With reference to his application dated 4th March 1914
 Messrs. Mahomed Ali Chohan, & Sons, Messrs. is informed
 that the plan submitted by him for building Compound to walls
 on plot No. 121 Survey Sheet 89
 situate in Street 4th April
 Quarter, is approved, and permission to build in accordance therewith is
 granted. The building to be erected subject to the Byelaws and Rules of the
 Municipality.

SHOWING COMPOUND WALLS TO BE BUILT

ON PLOT NO 121 SHEET K9

LYAREE QUARTER

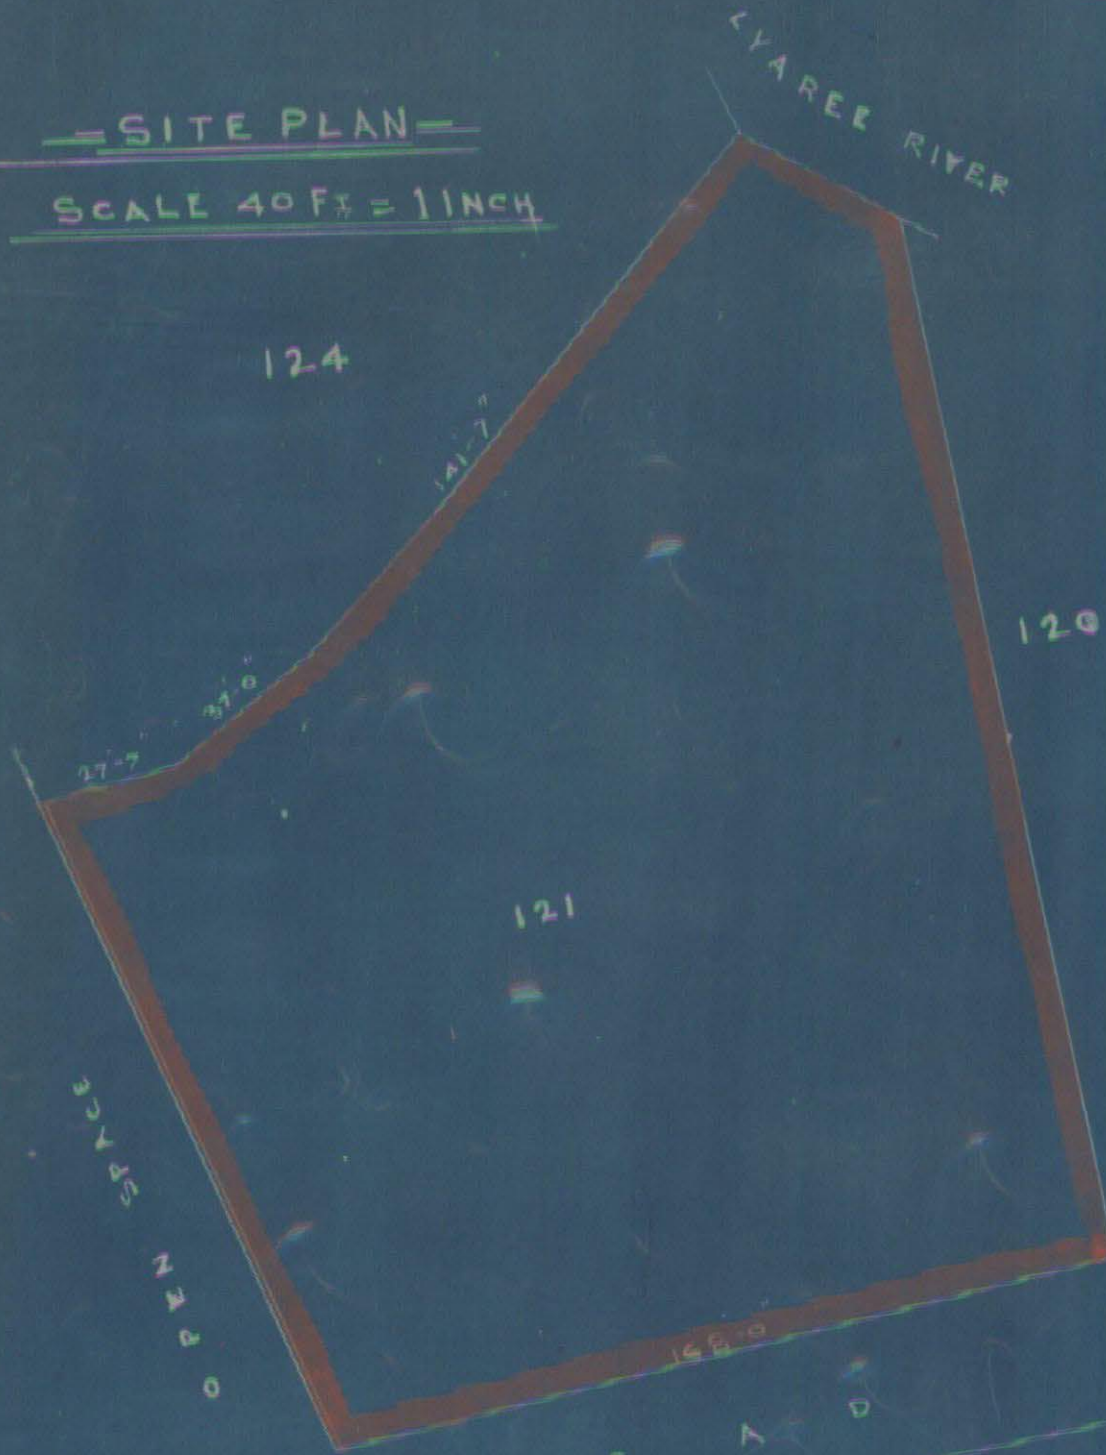
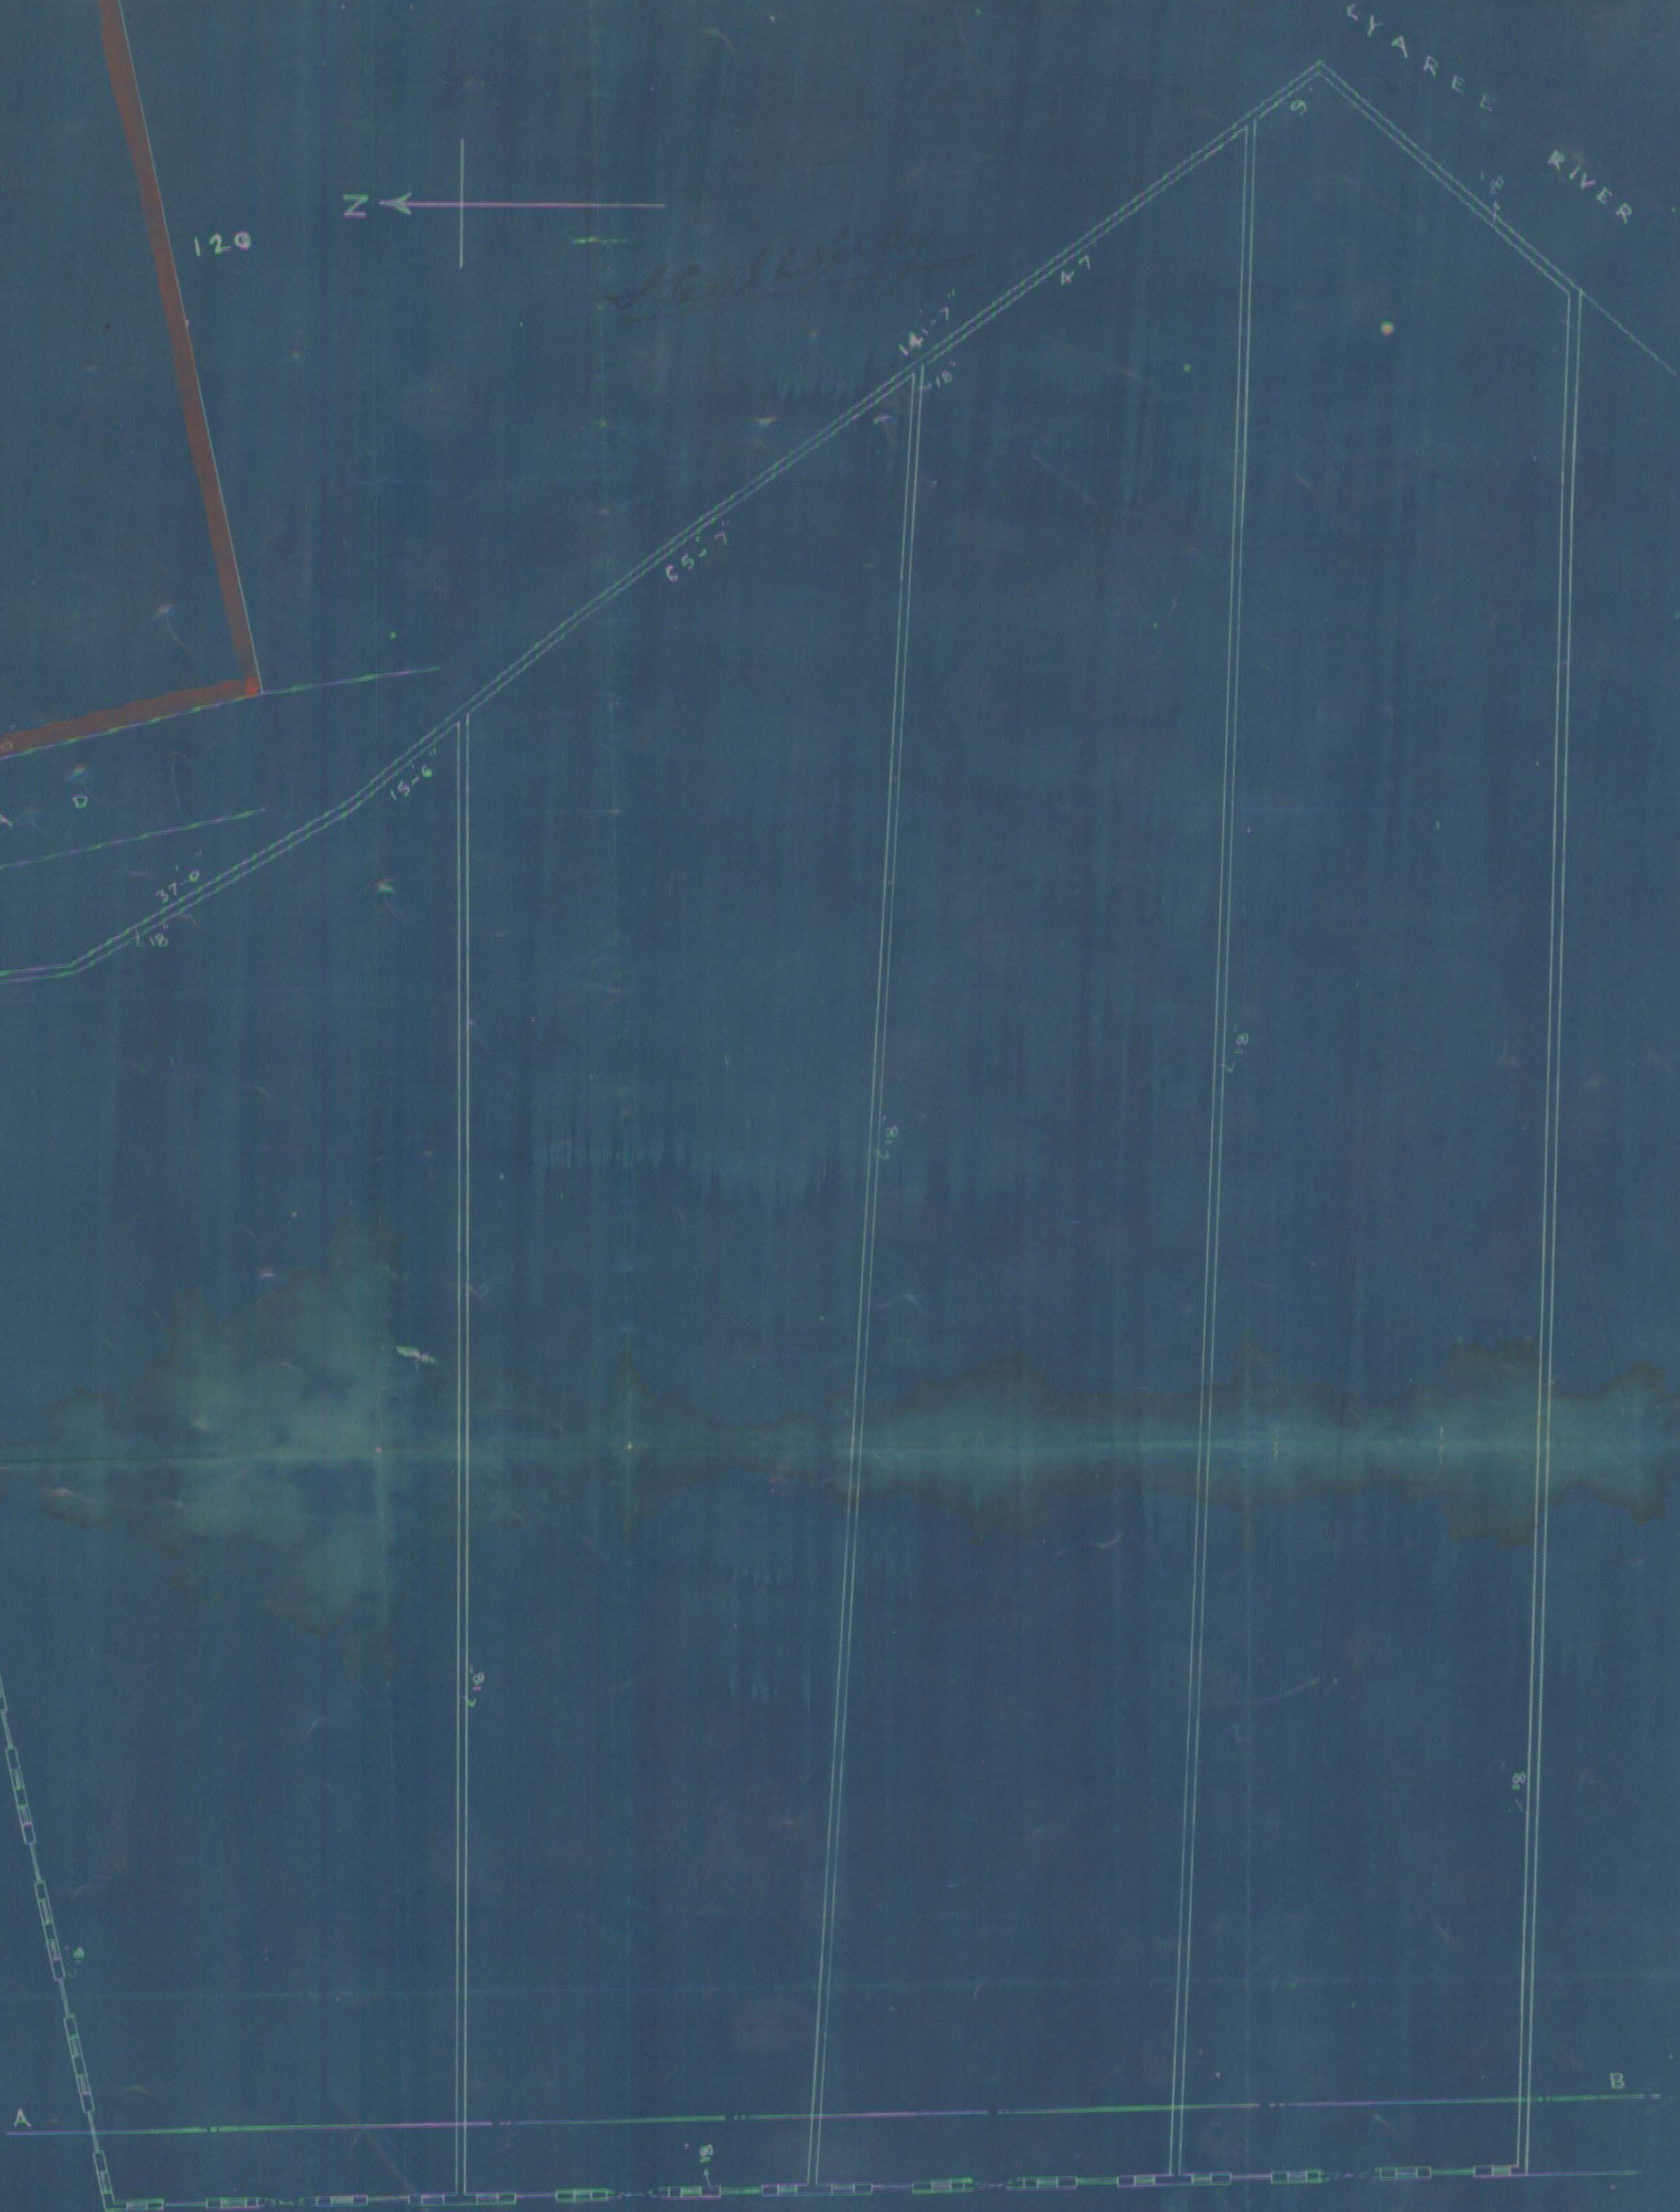
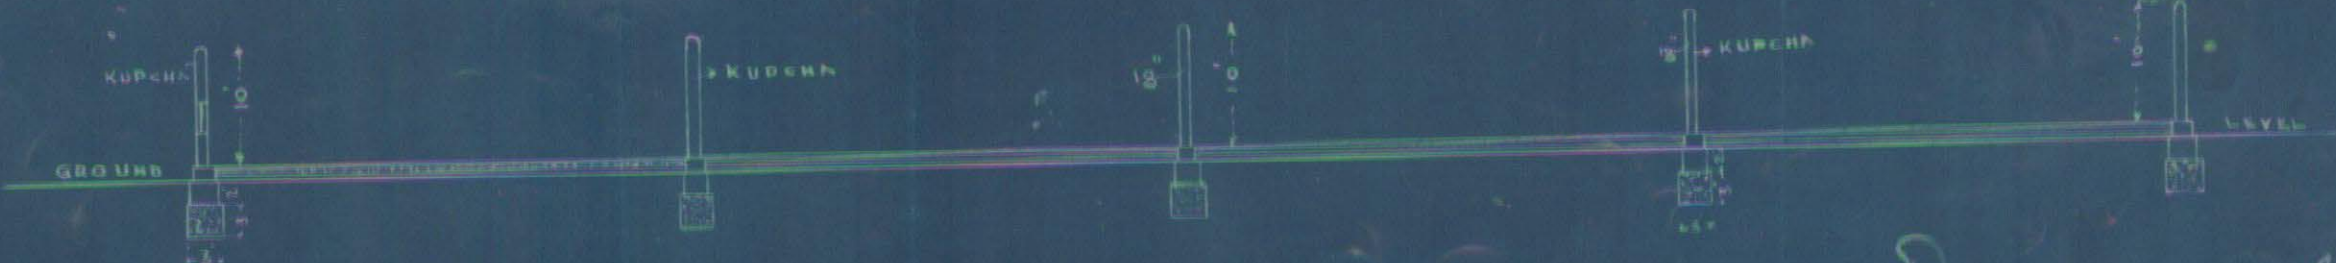
With reference to the City Deputy
Collector's letter of 5. 12. 14. dated the 12th inst.
with a sketch of the compound walls
to be built on plot no 121. The
quater, they report that this plot
has only one road. and towards
the north end. Vacant land on which
they propose to open doors & windows.
and it is not known whether there
will be a road to be provided.
It maybe considered to allow to
build a compound means to
allow the plot to be divided
into divisions as it purchased
by four defunct timber merchants.
Request your order -

Forwarded to the C.D.C.
for orders. The applica-
tion is to sub-divide plot
No. 121 K.9 Gyare G. and
open boundaries on Municipal
land on the north. It is
probable that a road will
be required along the north
of this plot in which case
permission may be
given to open the doors
and windows. The plot is
a large one & a thing
that appears to be
left for a road between
A & B (on tracing) before
permission is given to
build a fence compound
wall.

With reference to your letter No.335 dated 6th instant, I have the honour to inform you that there is no objection to the erection of compound wall with partitions on plot No.121 K-9, Lyari quarter as per plan submitted.
